NOTICE TO BIDDERS "B"

MAGIC JOHNSON PARK MAKE READY AND PARKING PROJECT SPECS. NO. 7918; C.P. NO. 8A189

This Notice to Bidders "B" extends the bid due date, clarifies certain portions of the Project Manual, responds to questions received, and forms a part of the Contract Documents.

ENLARGED ELECTRICAL SITE PLAN

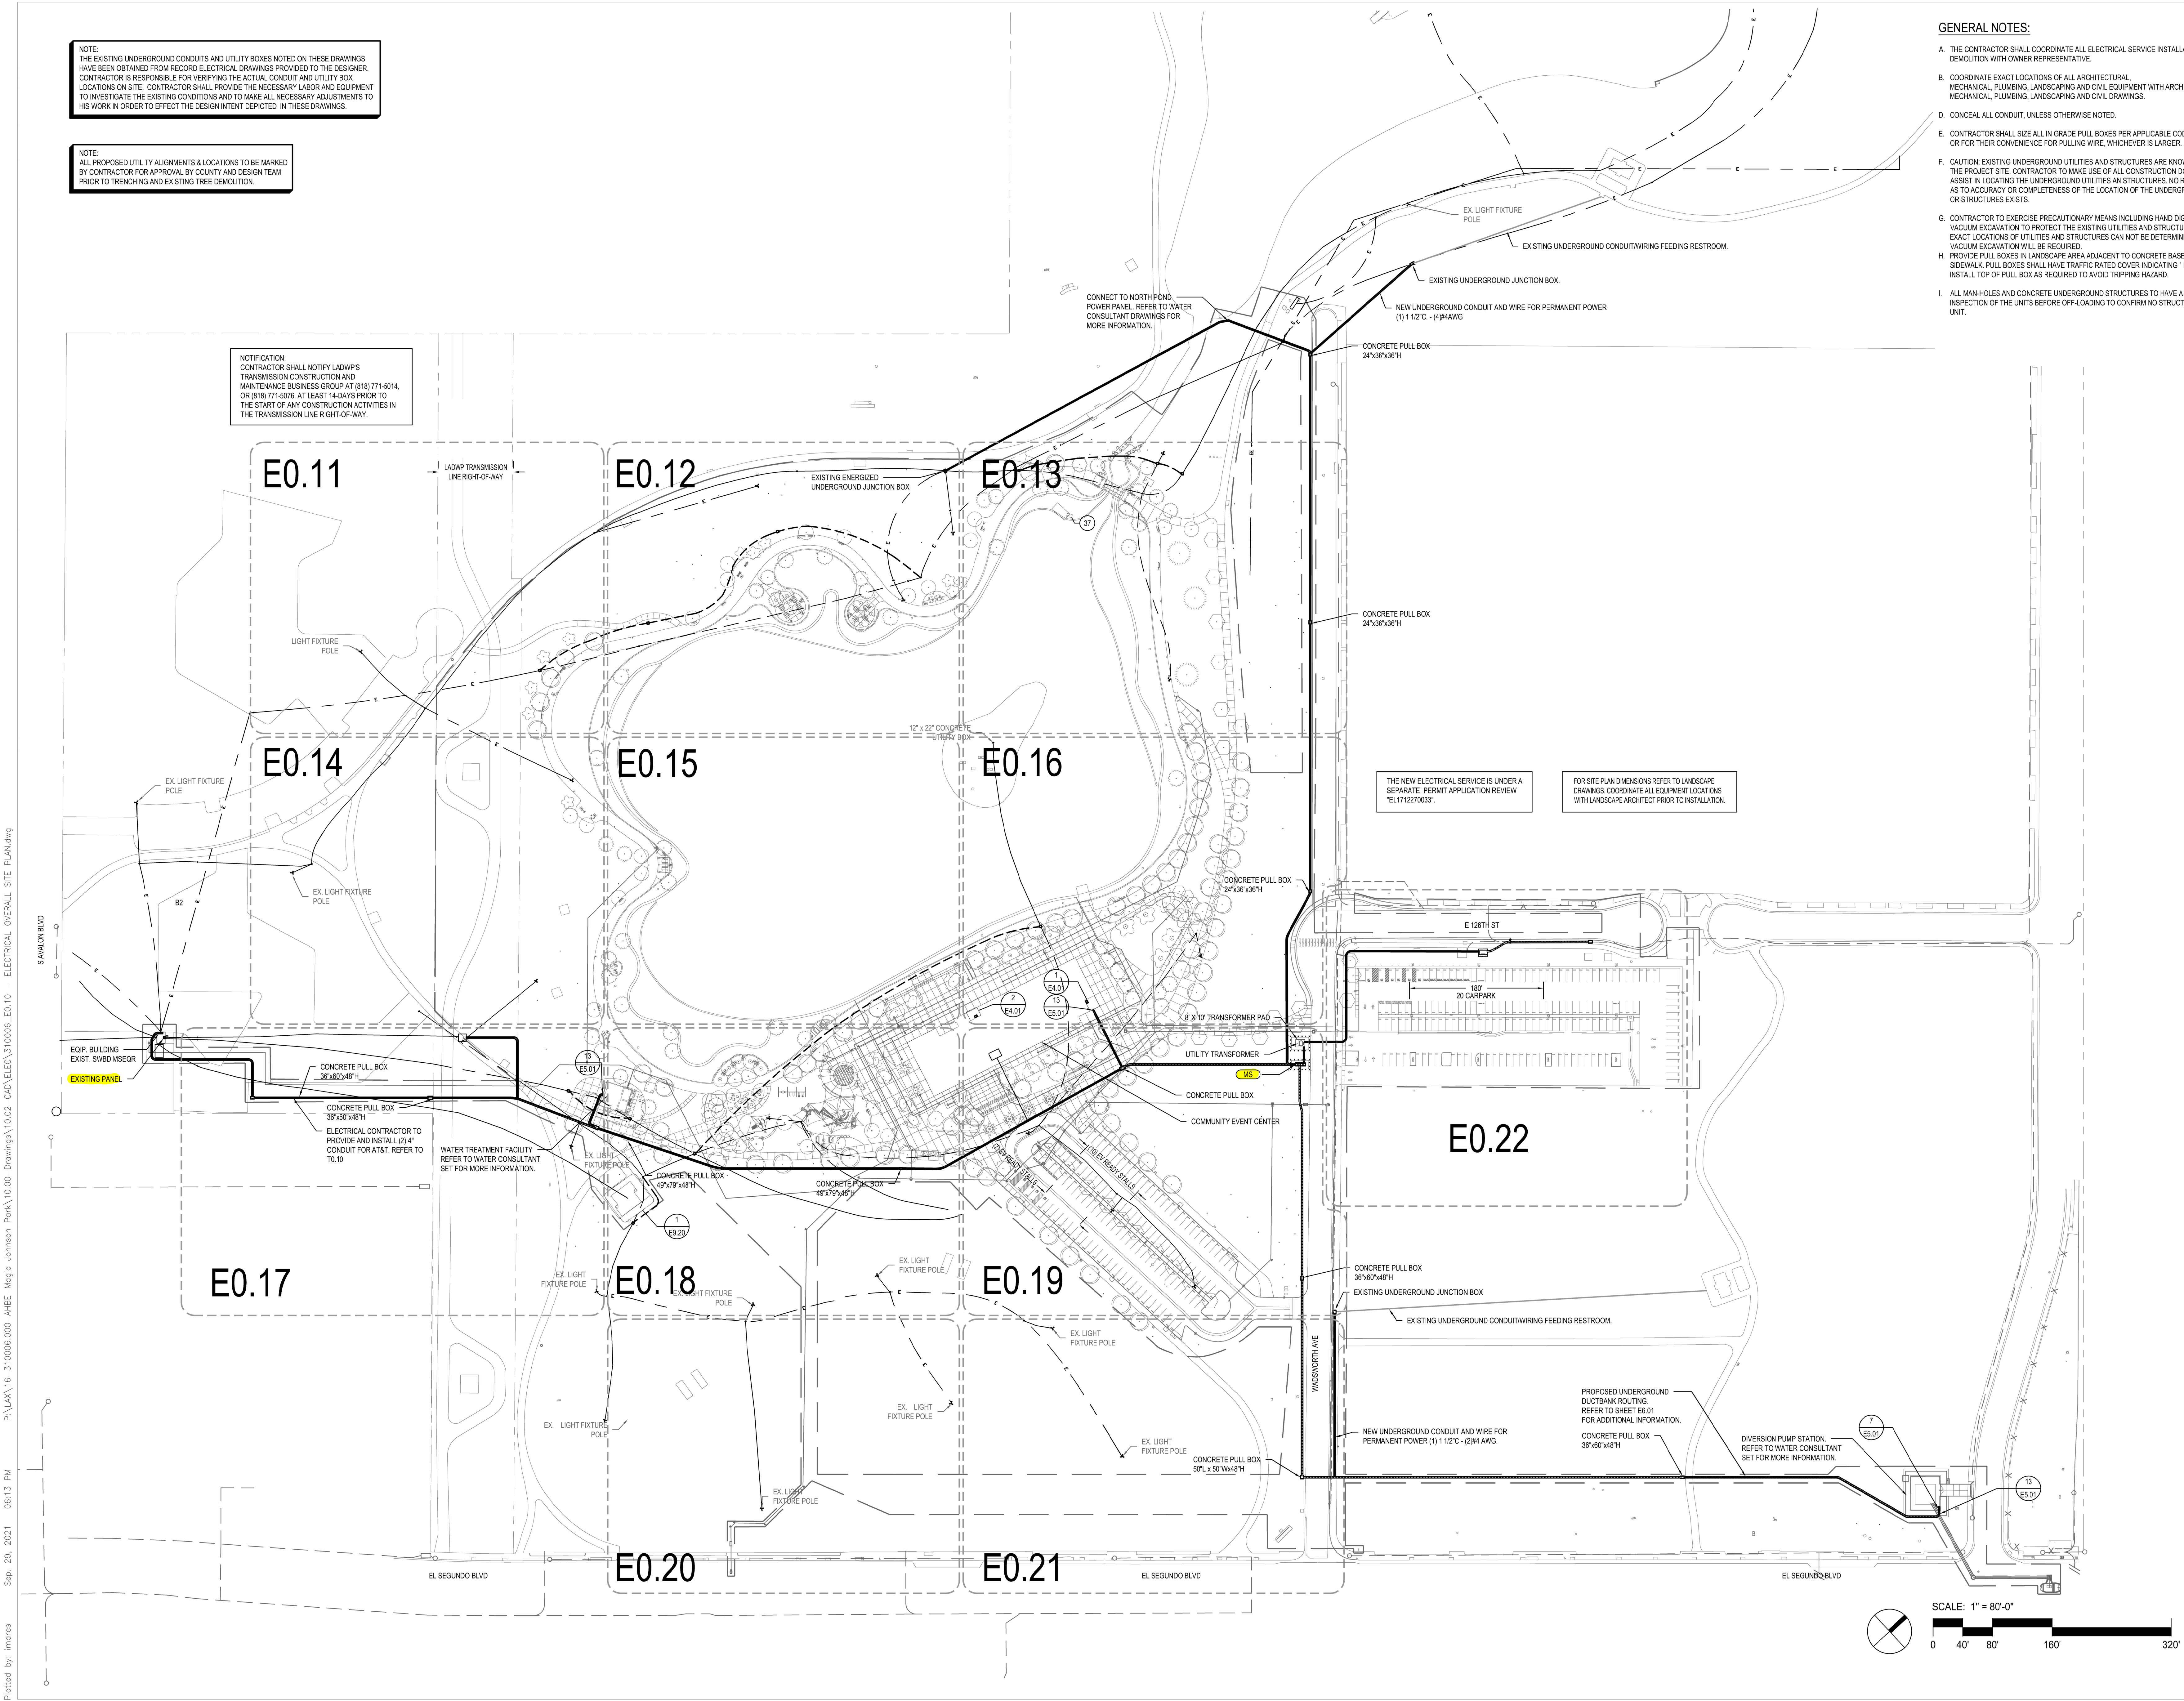
by the owner? If we are required to tag trees please provide nursery location so travel expense can be calculated.	
24	Tree protection notes state that herbicides cannot be used within 100 feet of a tree. This is in direct contradiction to the grow/kill specification to remove the turf. Please provide direction as we cannot kill the turf adequately without herbicide.	Acceptable to use in areas where grow and kill is required.
25	There are several mentions of an arborist inspections and recommendations to the maintenance and care of the trees. Will this service be supplied by the owner or contractor?	Contractor.
26	Sheet E201 Electrical Demolition Plan calls for the removal of the existing electrical panel. Who will be responsible for the power kill to the panels? If the contractor please provide a location and single line diagram for the master panel so we can ascertain the amount of work required to safely remove the panels.	Refer to attached SLD PDF file named MJP Phase 1A_V2_6 Electrical – SLD (Attachment 3 of this Notice).
